CITY OF ALBUQUERQUE

**RE: McDonalds – Coors and Hanover
1501 Coors Blvd NW
Request for Certificate of Occupancy – 60 day Temporary
Hydrology Final Inspection - Approved
Engineer's Stamp Date 4/5/17 & 8/23/17 (J11D037)
Certification Dated: 12/19/17 & 12/21/17**

C7.0

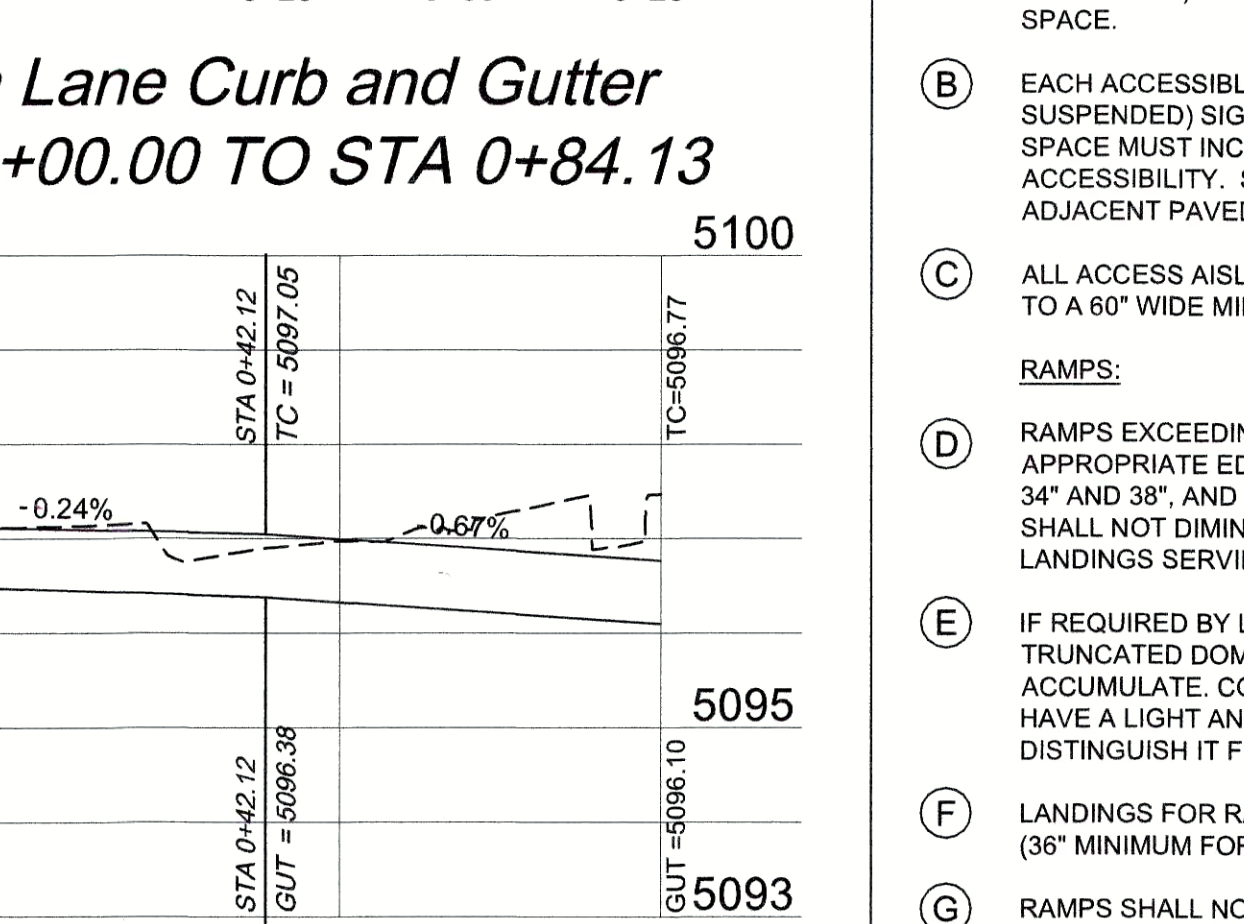
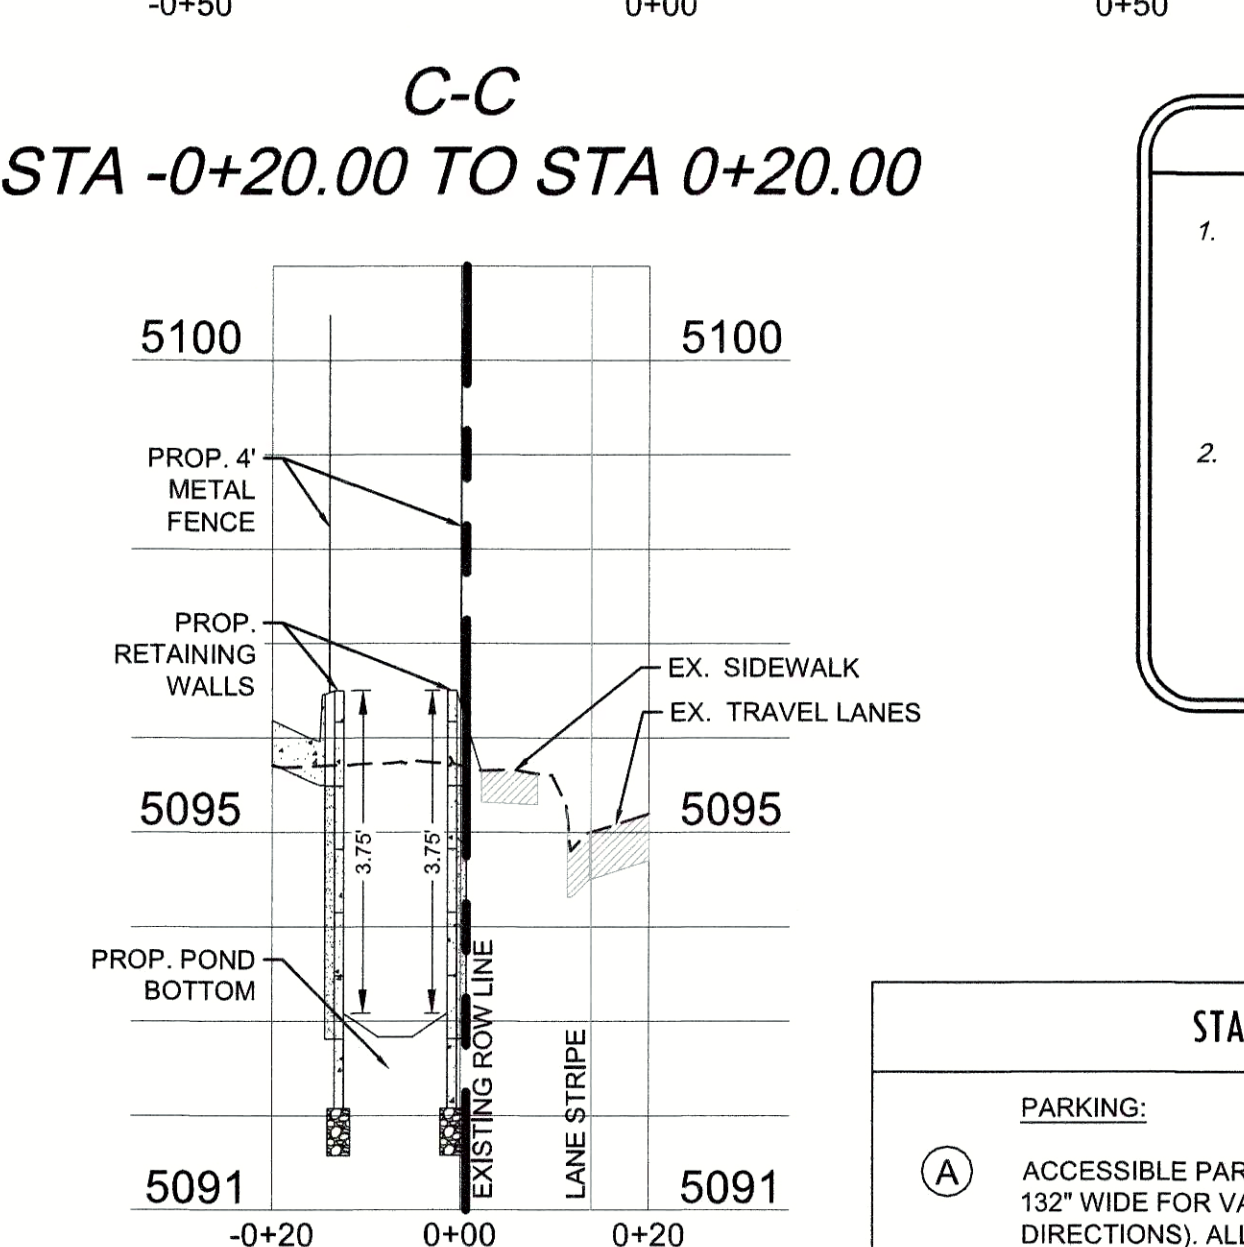
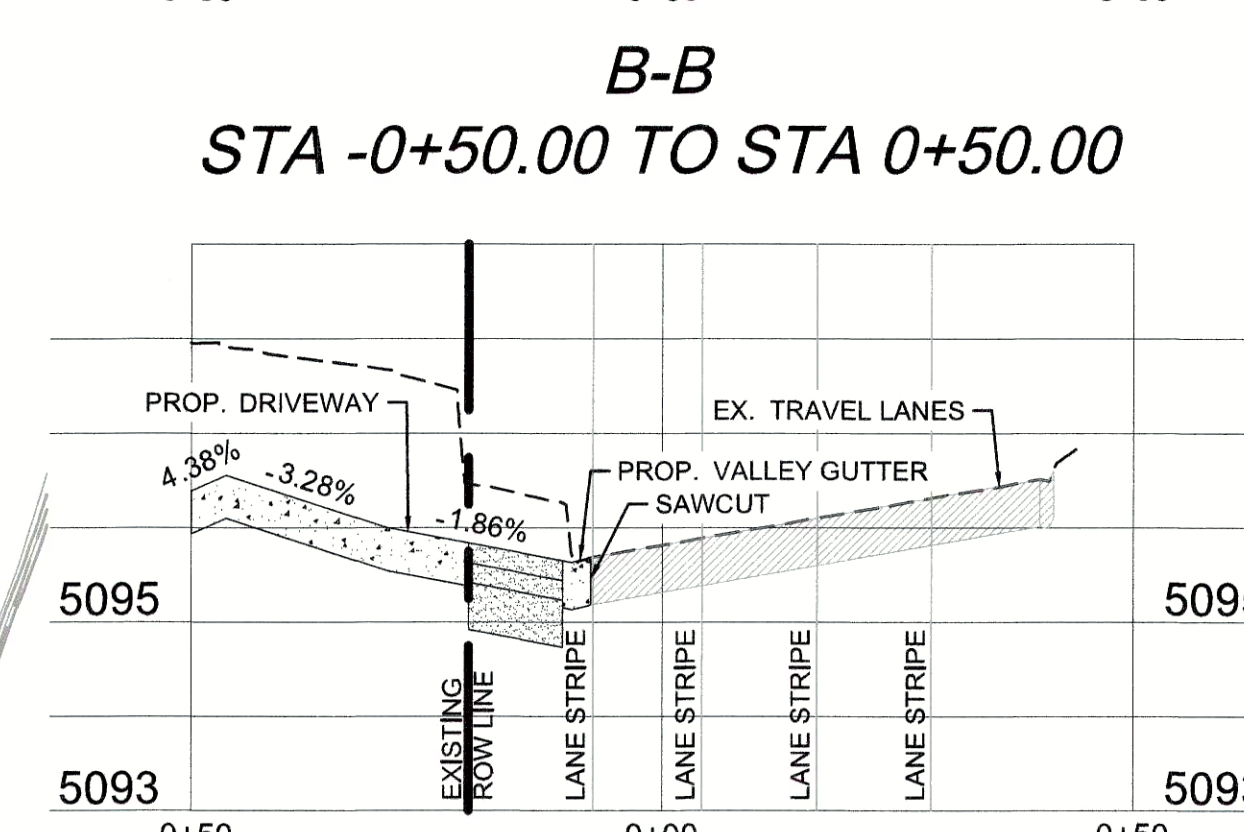
1. A \$25 check, payable to City of Albuquerque, is required for recording the Drainage Covenant. Please provide this to Madeline Carruthers (mtafoya@cabq.gov, 924-3997) or Charlotte LaBadie (clabadie@cabq.gov, 924-3996) in DRC-Construction Services (4th Floor, Plaza del Sol).
2. The Bernalillo County Recorded Drainage Covenant will need to be provided with the drainage certification. DRC-Construction Services will record the Covenant; please ensure Hydrology receives a copy as well.
3. A new Drainage Certification of the Grading and Drainage Plan (C7.0 and C8.1), with a new certification date will need to be provided for requesting permanent C.O.
